**ADDENDUM A**  
**Staff Report Z-43-12-7**  
March 15, 2013

<b>Estrella Village Planning Committee Meeting Date</b>	March 19, 2013
<b>Planning Commission Hearing Date</b>	April 9, 2013
<b>Request From:</b>	R-5 (70.46 Acres) R-5 (Approved C-2) (11.40 Acres) C-3 (1.29 Acres)
<b>Request To:</b>	PUD (83.15 Acres)
<b>Proposed Use</b>	Planned Unit Development to allow for industrial development
<b>Location</b>	Northwest corner of 59th Avenue and Van Buren Street
<b>Owner</b>	James F Kenny/El Dorado Van Buren 80 LLC
<b>Applicant/Representative</b>	Paul Gilbert/Beus Gilbert PLLC
<b>Staff Recommendation</b>	Approval, subject to stipulations

This addendum is to revise the Street Transportation Department stipulations. The applicant has been working with staff and both parties have agreed to address the traffic comments that were provided by the City of Phoenix during the preliminary site plan approval process. Proposed stipulations to be revised are in bold and strikeouts below start at stipulation #17.

63<sup>rd</sup> Avenue Geometric Design

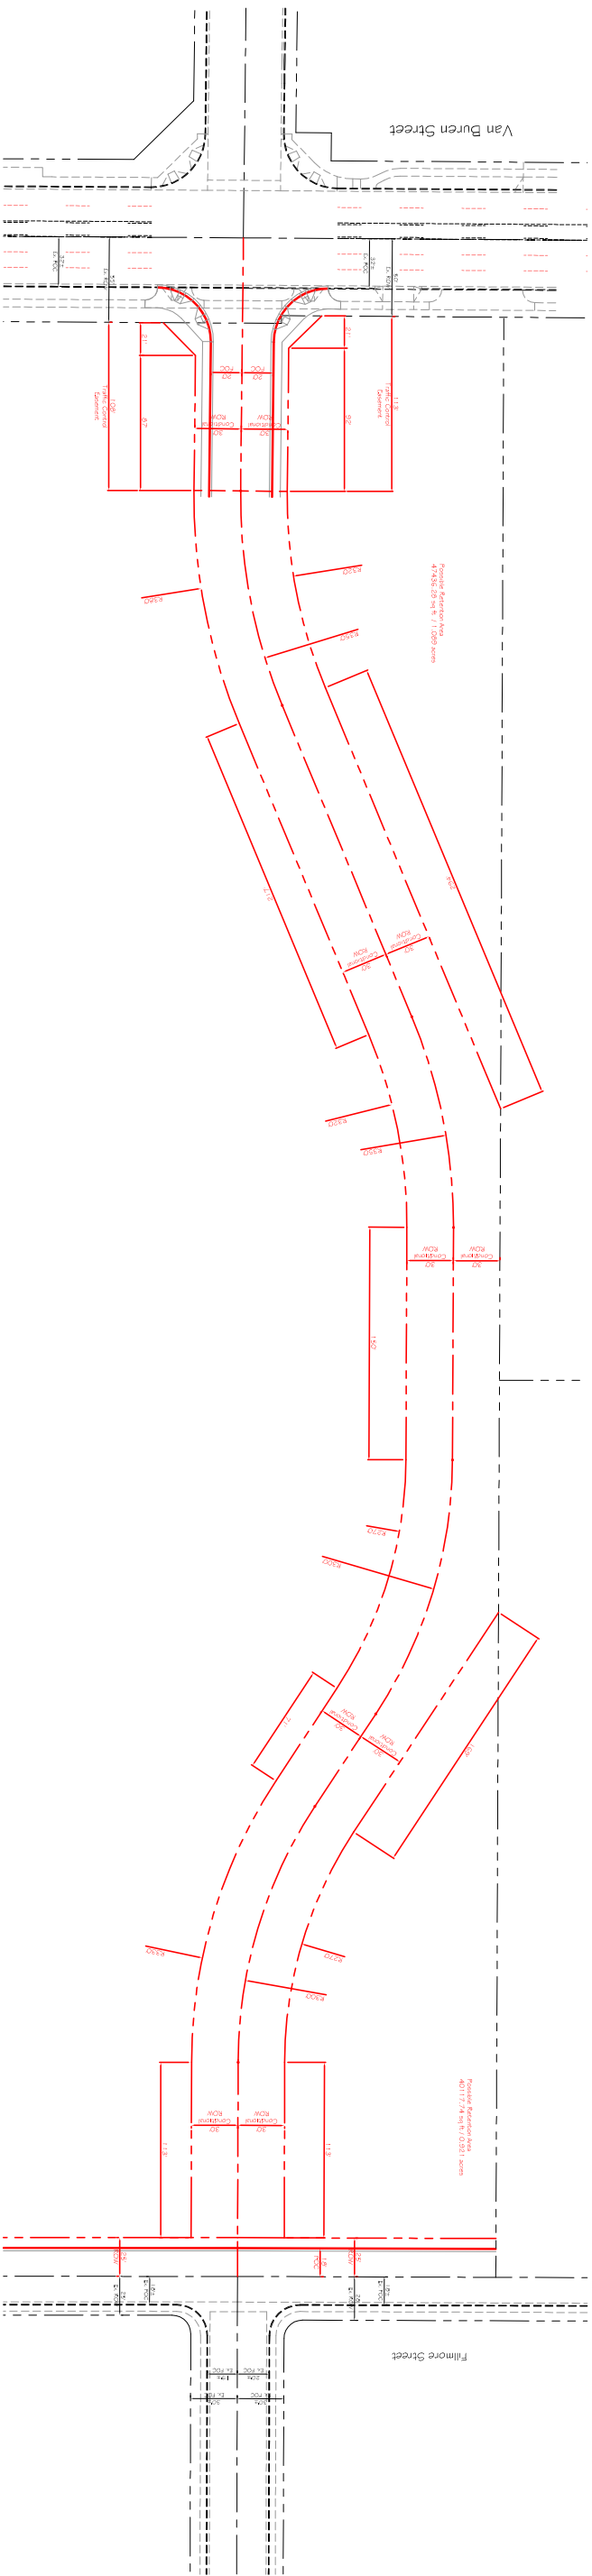
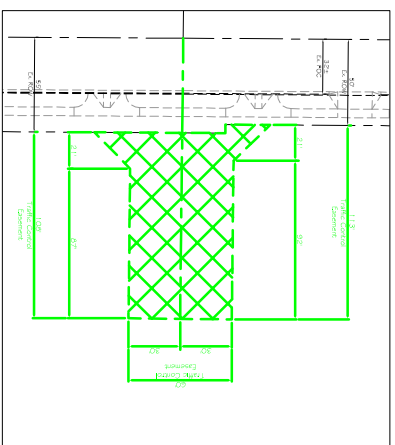
21. **The developer shall dedicate conditional right-of-way sufficient to accommodate the extension of 63rd Avenue from Fillmore Street to Van Buren Street. The geometric alignment for 63rd Avenue shall be as per plans approved by the Street Transportation Department (see attachment). This future connection may be necessary based upon limited access to the neighborhood upon completion of the South Mountain Freeway and other area developments.**
